**City of Portland, Oregon - Bureau of Development Services**1900 SW Fourth Avenue • Portland, Oregon 97201 | 503-823-7300 | www.portlandoregon.gov/bds**Permit Revision Submittal Requirements and Application**

MEMORANDUM

RE: N Concord Remodel
6207 N Concord Ave
Portland, OR 97217

19-171775-REV-0-RS

2
 53
 REVISED MAIN FLOOR PLAN
 ALL DETAILS OF CONDITIONS OF THE SAME TYPE ARE TYPICAL U.N.O.

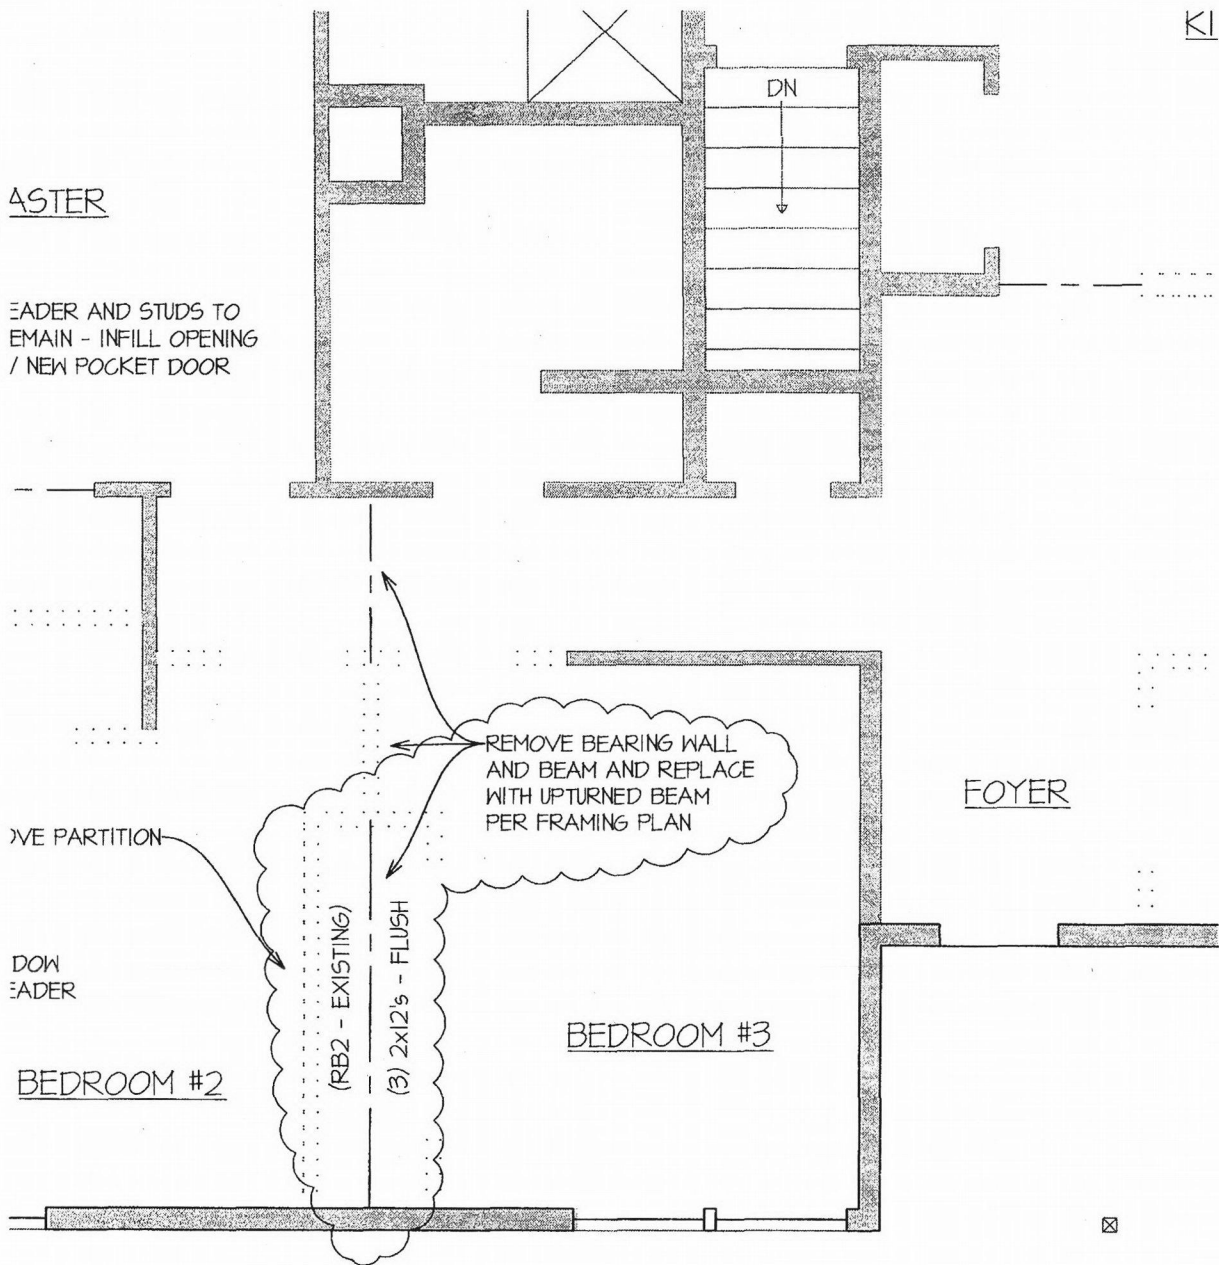
Please note that this change results in the removal of new loads on the main floor beam MFB2 and therefore the existing condition is acceptable without the additional LVLs and modifications specified in details D5, D6 and D7 on the permit set. Attached is a revised main floor framing plan showing this change.

BASEMENT PLAN & MAIN FLO

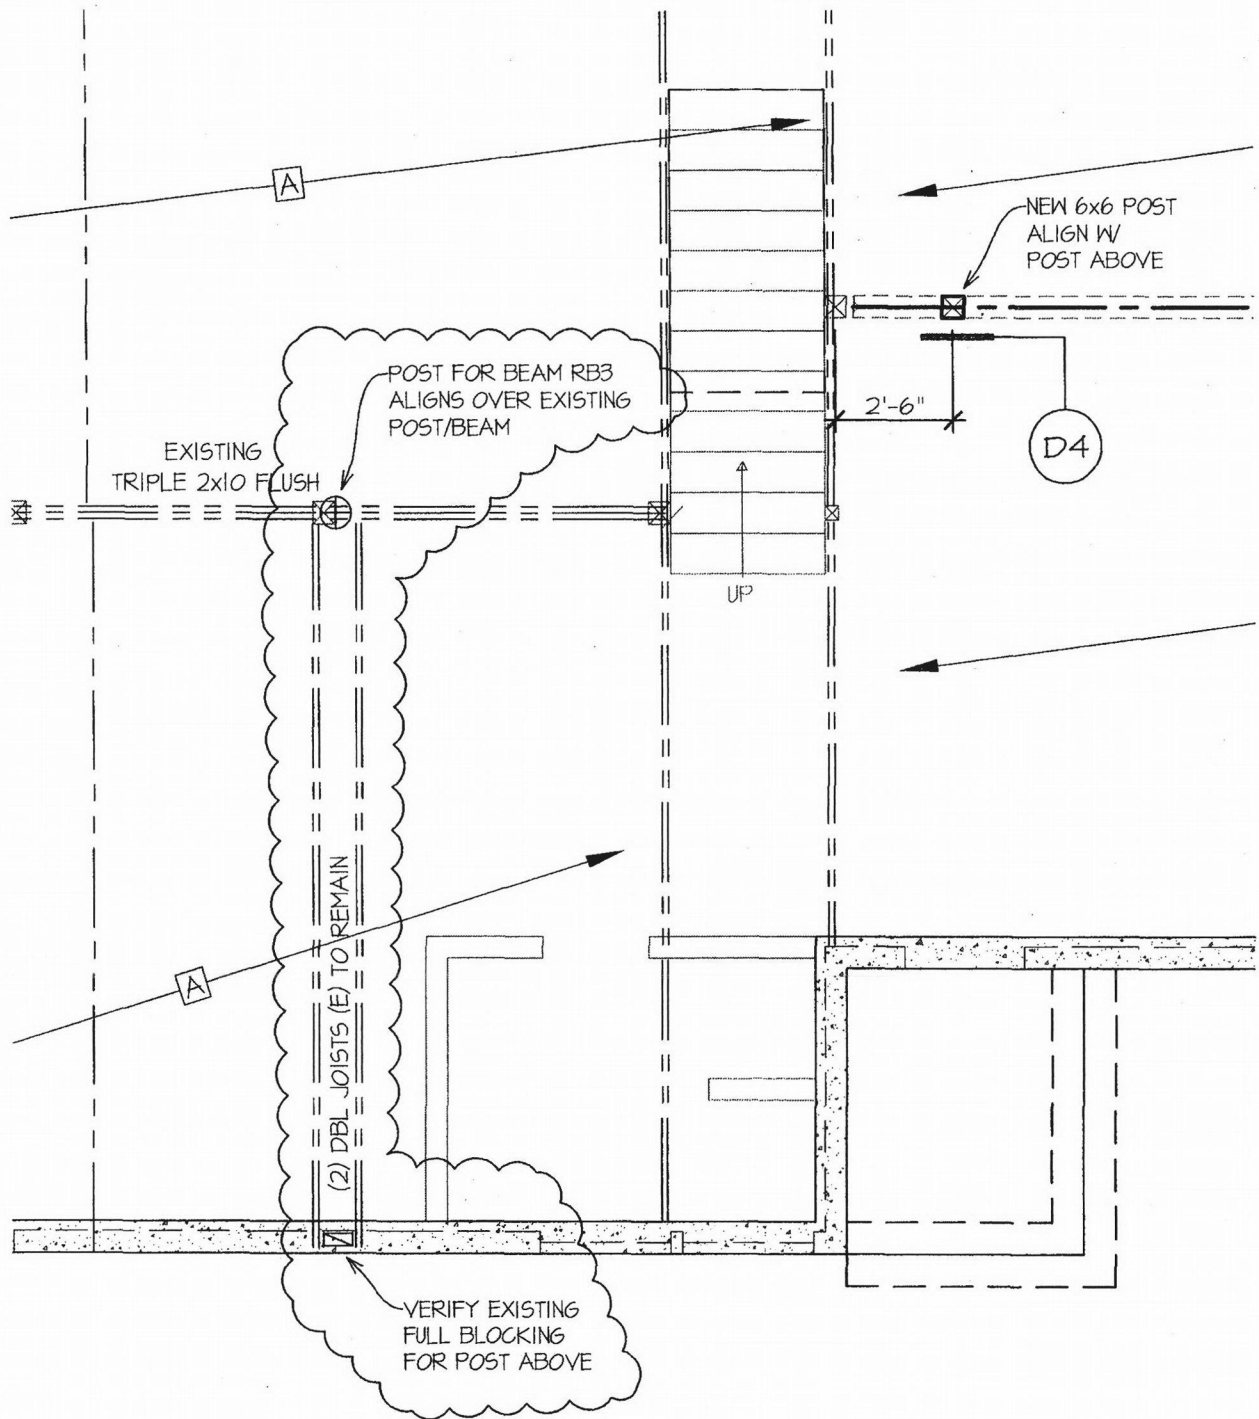
For constructability reasons, it was requested that we pursue an alternate framing solution which avoided bringing a point load down to beam MFB2 on the main floor framing plan on sheet S3. We have revised beam RB3 on the roof framing plan to span from the exterior wall to the hallway and it is now specified as an upturned triple 1-1/2x14 1.3E LSL beam, spliced per new detail R1. All existing diagonal knee brace posts/kickers, as well as all of the intersecting ceiling joists that currently bear on the existing beams/walls shall be supported by the new full length beam per revised detail D8. This modification has eliminated the need for detail D9. Please see attached revised framing plans and supporting calculations for more information.
